HARTING Product Change Notification

PCN/18/024/C+N

Title: **Minior change of HARTING RJ Industrial® IP20 plug housing -
External**

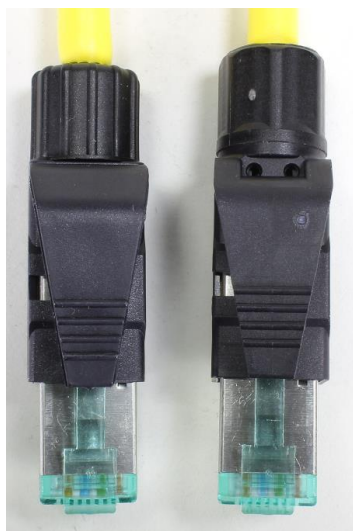
Because of a tool replacement process we carried out a minor redesign and improved the cable clamp of the plug hood. The new version now has the same cable clamp that we use with HARTING RJ Industrial® 10G series with a cable diameter from 4,5 to 9 mm. This is an additional improvement of this very successful product series.

The pictures above show the old and the new design. The new design can now also be equipped with the colour clips 0945 850 0001 - 0945 850 0010.

Old design

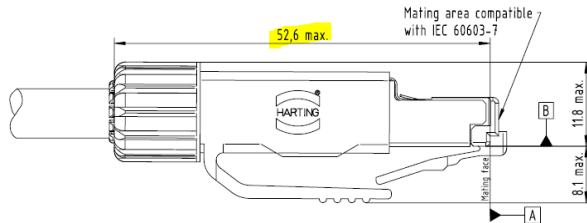
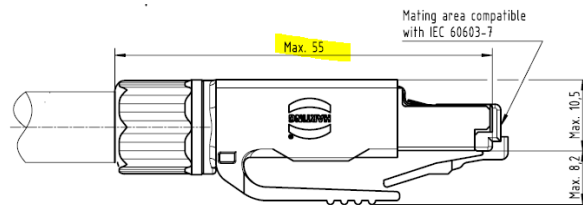
The dimensions are mainly identical. Only the total length has increased by about 2,4mm. See the drawings below.
